From: Emily Wade <Emily.Wade@midsussex.gov.uk>
Sent: 13 June 2025 10:21:26 UTC+01:00
To: "Caroline Grist" <Caroline.Grist@midsussex.gov.uk>
Cc: "Steve Ashdown" <Steve.Ashdown@midsussex.gov.uk>
Subject: 8 Newstone Cottages DM/25/1248 and 1249

Please find below comments on the above planning and listed building consent applications.

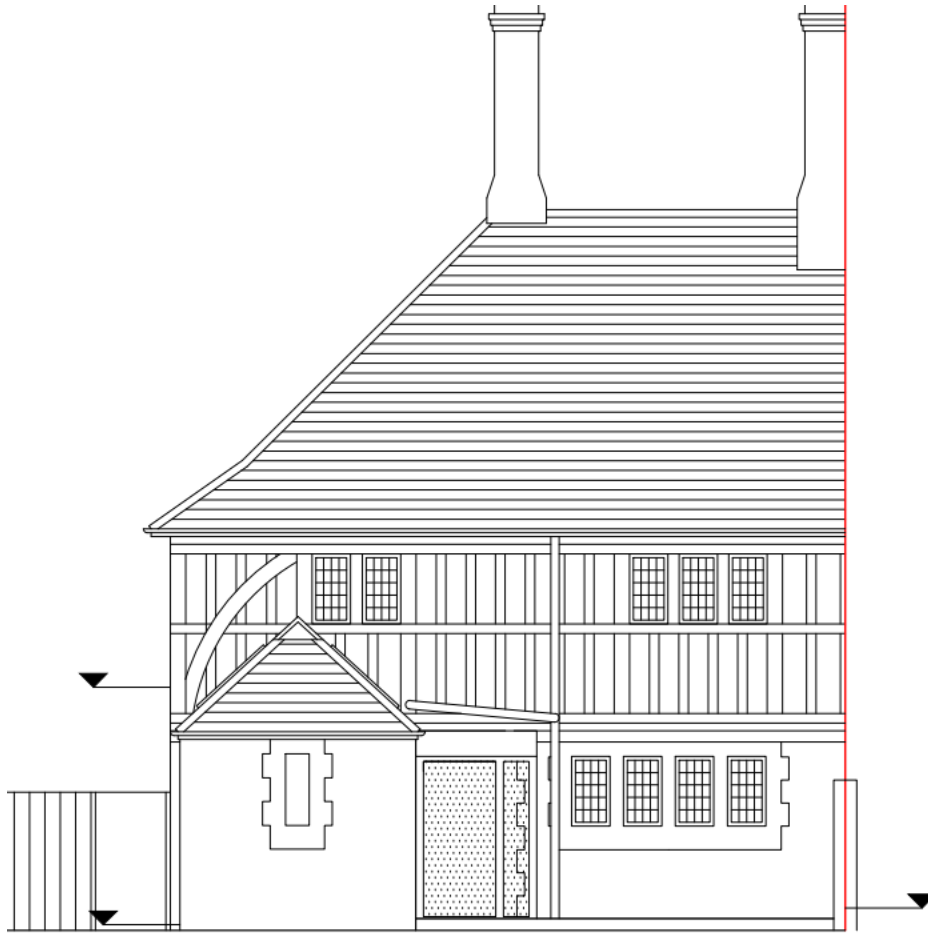
Following recent discussions relating to the context of the site and of the current proposal, I am adding below a brief summary of other recent permissions for rear extensions to the other properties within the Newstone Cottages group. This should demonstrate that the current proposal is inconsistent with these approvals, which in most cases were achieved following discussions with Officers resulting in sometimes significant amendments to the form and design of the proposed extensions.

Please see the approved rear elevation below:

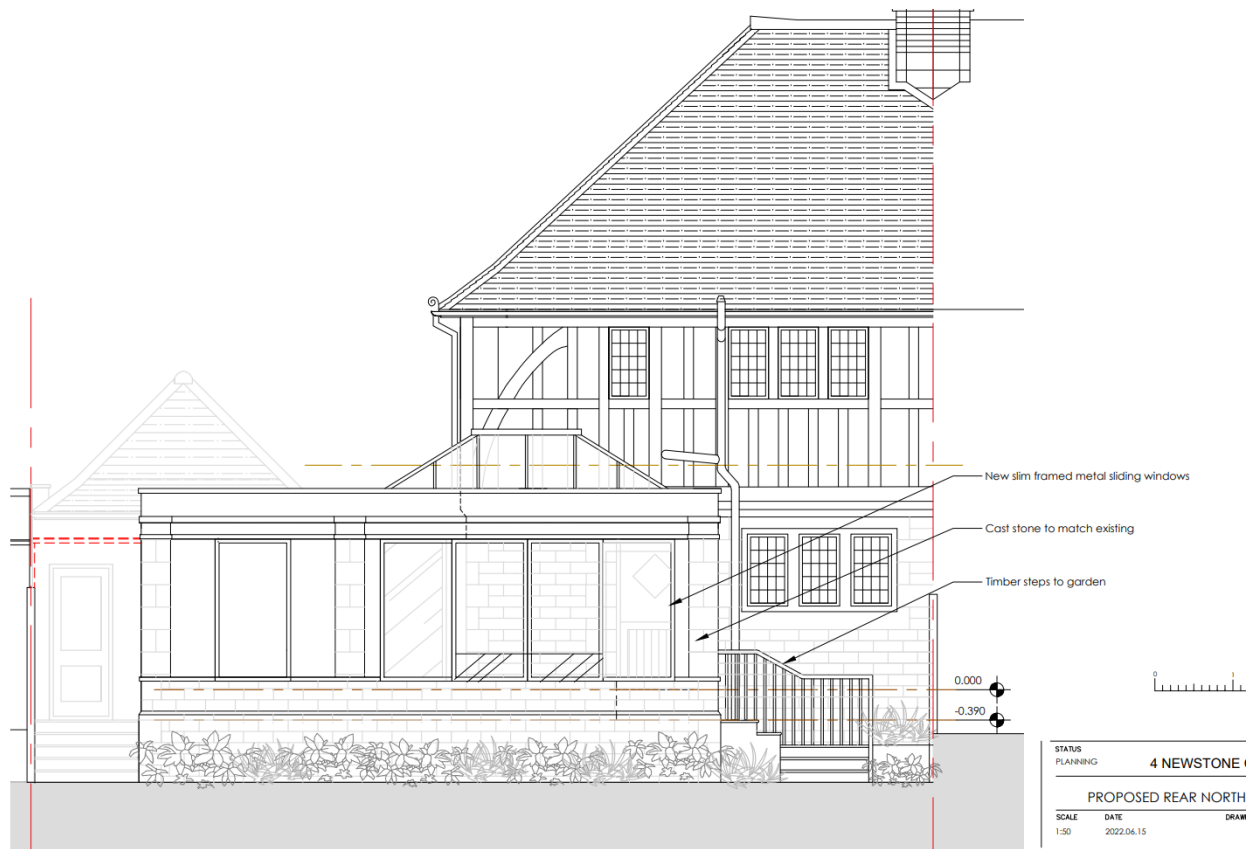
Planning permission and listed building consent were recently granted at no. 4 Newstone Cottages for an offset extension to the rear of the property (DM/22/2540). However this addition was smaller in scale than the proposal as submitted under the current application at no. 8 (when viewed in combination with the existing conservatory extension to this property), did not sit across the full width of the plot (or indeed the rear elevation of the house), was largely glazed across the rear elevation and had a large roof lantern.

This approval was achieved after lengthy discussions at pre-application and application stage to ensure that the addition was appropriately subordinate to the house, and of an appropriate form and lightweight elevational treatment, whilst also meeting the applicant's requirements.
